Access Compliance Report

Public Rights-of-Way

(Curb Ramps)

Intersection ID: 10020374	Main Street: BALLANTYNE CORPORATE PL	Cross Street: N/A	Location: S
ADA ID: 2978CC1BADF7	Ramp Type: Perp	Initial Pass/Fail: Pass	Overall Compliance: No
			Severity Score: 0.25
Codes/Mitigation Info/Possible Solution		Field Measurements/Component Compliance

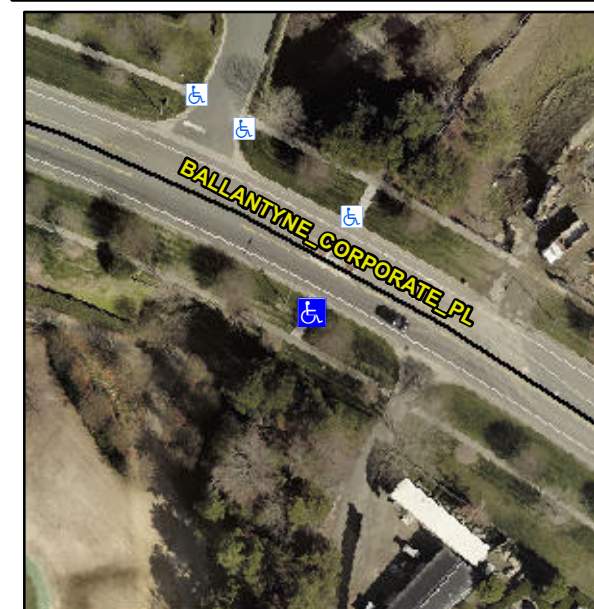
Possible Solutions:

Remove & Replace Landing.

PROW/ADA:

R304.5.3
